SERVICE BULLETIN

N° **139-629**

ATA 95 – FORWARD FLOATS COVERS UPGRADE

SERVICE BULLETIN SB2019-04 C DART AW139 FWD FLOAT LEFT AND RIGHT ASSEMBLIES UPGRADE

Figure 1: LH Pod Assembly Cover Cutout Location (RH Opposite)

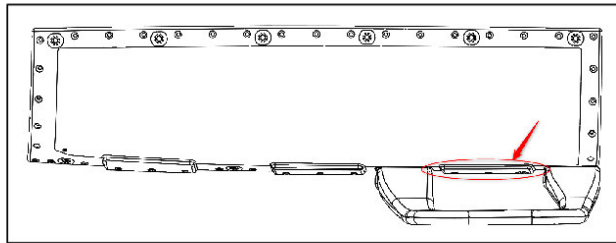
1. Inspect the cover from underside of the aircraft looking outboard at the FWD Pod Assembly in the indicated area in Figure 1.

Figure 2: RH Cover with Cutout (LH Opposite)

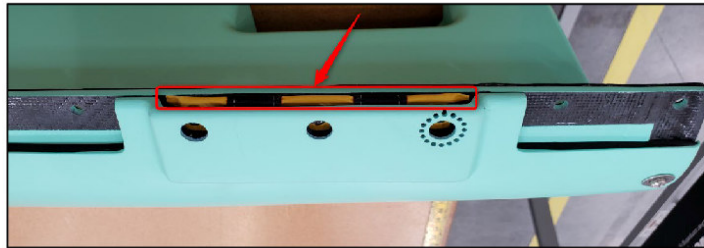
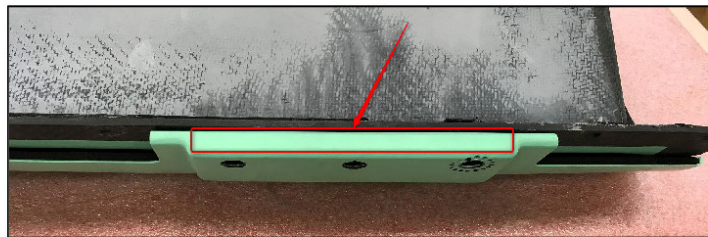
2. If the cover looks like Figure 2, with the correct cutout, no further action is required.

3. If the cover looks like Figure 3, missing the indicated cutout, proceed to Section 2.2.

Figure 4: Screw Locations on Pod Assembly Cover (LH shown, RH opposite)

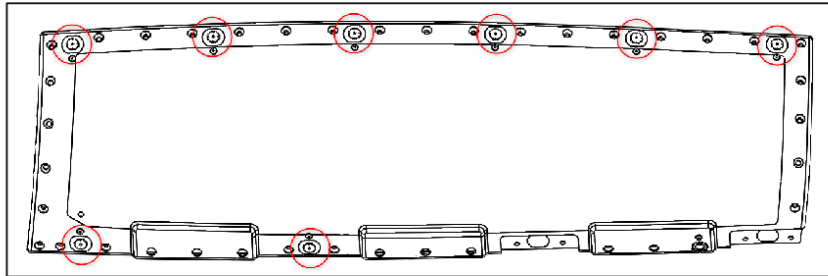
1. Remove the cover from the forward pod assembly by unscrewing the eight screws (P/N 601.2279) on the front of the cover as indicated in Figure 4.

Figure 5: Cutout Location (LH shown, RH opposite)

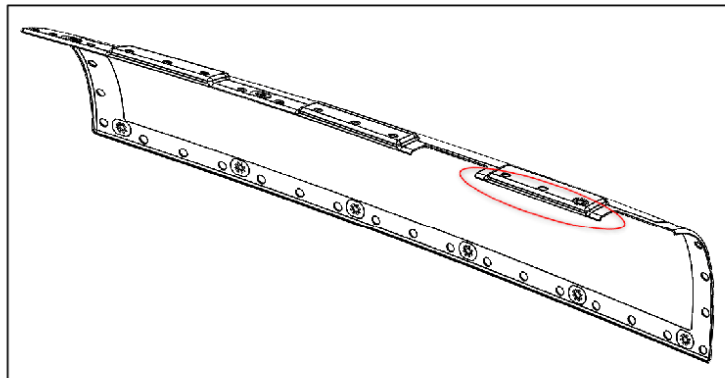
1. On the cover, identify the location where the cutout needs to be added (Figure 5).

Figure 7: Marking Template Placement on Cover's Edge (LH shown, RH opposite)

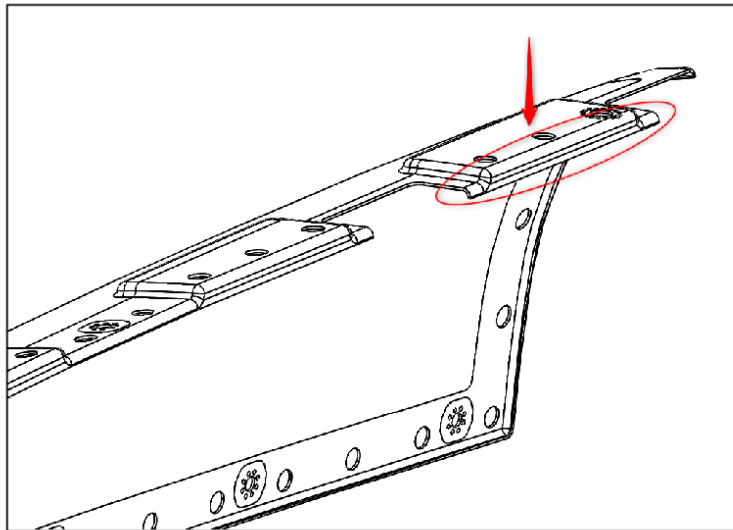
2. Place the provided marking template (P/N 607.2710) on the edge of the cover's flange as shown in Figure 7 and Figure 8.

Figure 9: Marked Cover

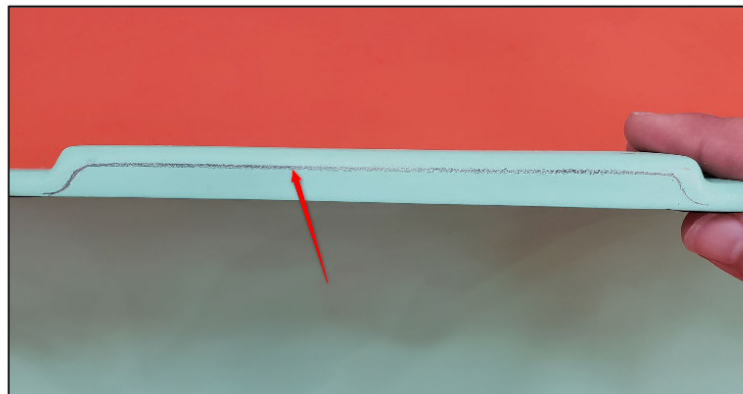
3. Mark the cover with a pencil or marker as shown in Figure 9.

Figure 11: Reference Dimensions (LH shown, RH opposite)

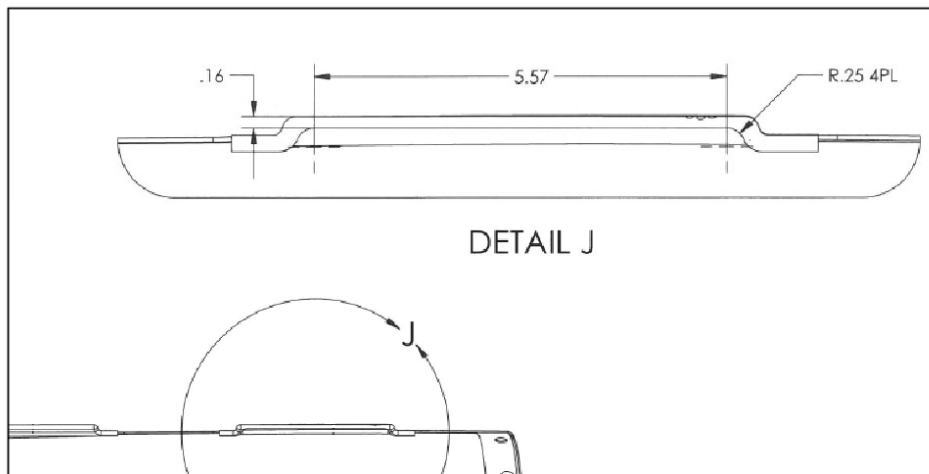
6. Inspect the cutout using the marking template and reference dimensions given in Figure 11.
